UNITED STATES PATENT AND TRADEMARK OFFICE

10/553,392

Office Action Summary	Application No. 10/553,392	Applicant(s) PECORARI ET AL.	
	Examiner CATHLEEN R. HUTCHINS	Art Unit 3672

DETAILED ACTION

Fig A: taken from Ricalton, et al. Fig 1.

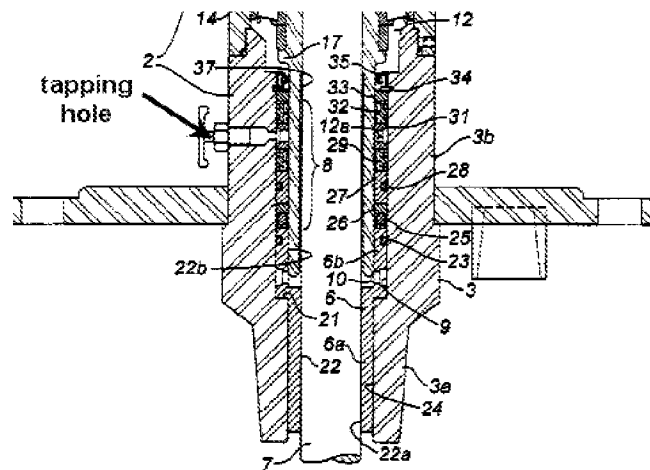
Ricalton, et al. teaches a pump drive head with an integrated stuffing box 1 comprising: a power transmission that rotates the rod 39, as described in the Abstract, coupled to a rotating pump drive shaft 39; a stuffing box 1; a thrust assembly 13 to take tensile force; wherein power transmission comprises a tube 11 to be rotated coaxially with the shaft having two different diameters with the larger diameter at top at 11b and the smaller diameter below along reference number 8, which is connected at its bottom end to a sleeve 6 for rotation, wherein rotary seals 42 fit over the smaller diameter of the tube to establish fluid seals between the tube and stuffing box, the outside diameter of the seals smaller than the larger outside diameter of the tube, and wherein the tube-to shaft fit has static seals 8, in which the seals are adapted, by virtue of a retainer ring 27, to come away with the tube; a gasket 26 connected to the retainer ring of the seals on the sleeve; an outside-communicated tapping hole see Fig A below downstream of the gasket and the seals; rotary seals include packing seals 32, oil seals 29 downstream of the rotary seals and inlet hole, with packing mounted between the tube and inner seat of the stuffing box; static seals are in the joint region between tube 11 and sleeve 6 and compressed to make a seal in the skirt of the top cover that is along 2; the tube is connected to the thrust assembly for rotation by rotating hub 20 held in place by tighten-down means 11a in the upper portion of the drive housing with a roller thrust bearing and bell 5 to enclose the hub and bearings.
